**COLORADO**  
Division of Reclamation,  
Mining and Safety  
Department of Natural Resources

June 13, 2022

**RE: New Elk Mine, C-1981-012, Permit Revision No. 5, Adequacy Review No. 3**

Figure 1: Screenshot showing records of constructed wells from DWR database with permit category "Residential" (pink dots) overlaid on proposed Map 1 and satellite image

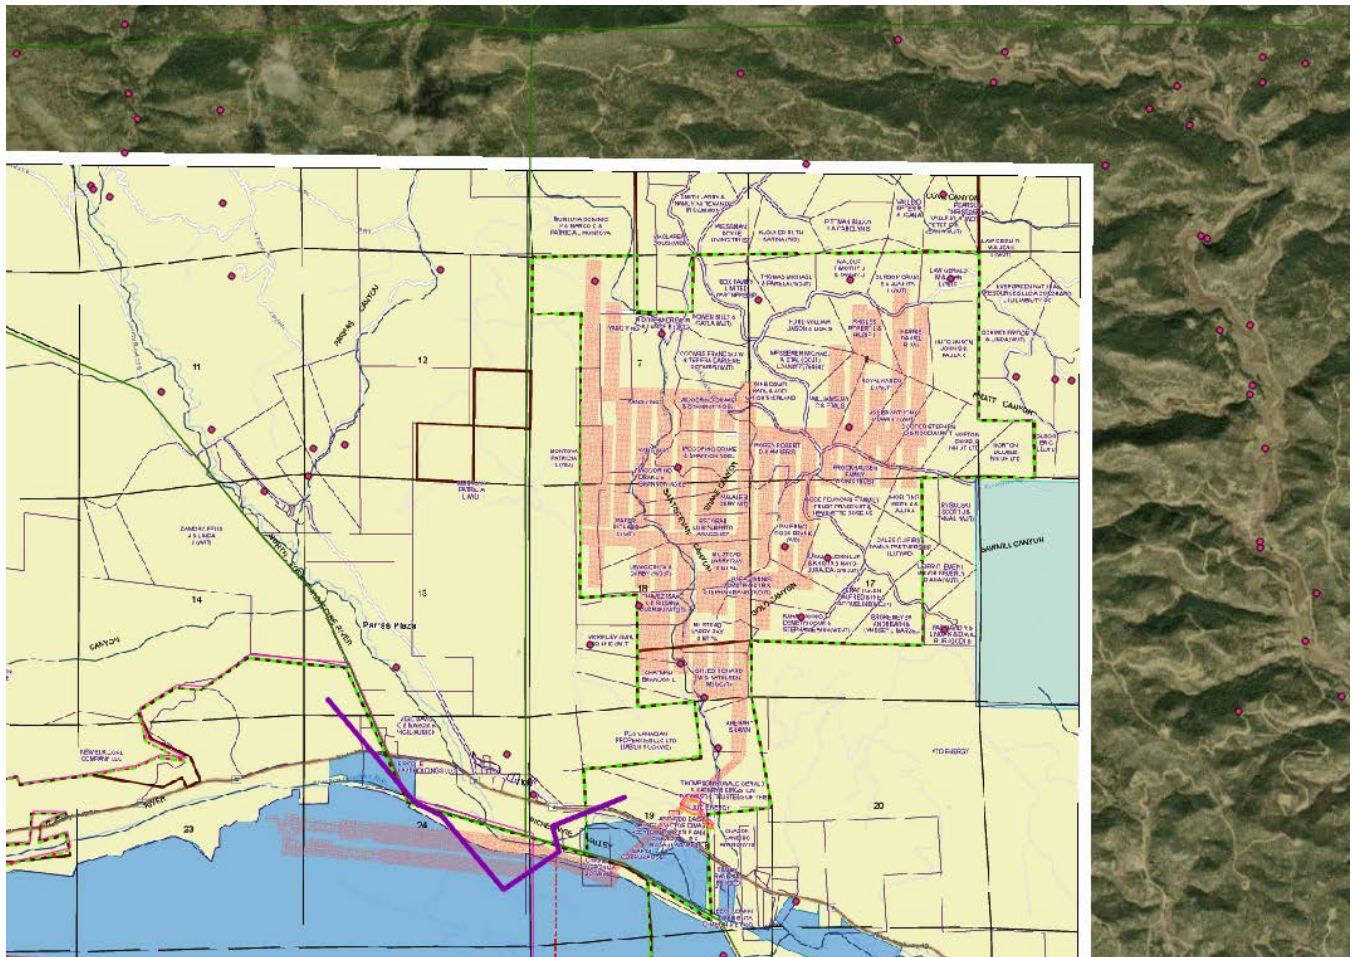
1. Minimal revisions have been proposed to section 2.04.7 of the PAP, however a complete description of the hydrology in the area of the mine is necessary before the consequences of mining can be assessed. It is clear at a cursory review that parts of section 2.04.7 are out of date (for example, Table 10 presents a groundwater user inventory, but the Colorado Division of Water Resources database contains many records of wells that have presumably not been included in the inventory, as is shown in Figure 1).

**Please review section 2.04.7 of the PAP and update it as necessary given the expansion to the permit area proposed with PR-5.**

- a. **NECC Response:** Table 10 has been updated based on Colorado Division of Water Resources database search and Exhibit 11 has been updated with all the permitting documents. Map 8 has also been updated with new wells along with creating a map series (Map 8a through Map 8d) showing four detailed areas at a scale of 1" = 800' so it's easier to identify features.
  - b. **DRMS Response:** Please see the adequacy review items identified under section 2.04.7 and respond accordingly.
2. Section 2.04.7 refers to Map 8, Regional Hydrology. The proposed revision to Map 8 is a scanned image of the currently approved Map 8, dated May 10, 2012, with the proposed permit boundary overlaid on it. The data on the map has not been updated.
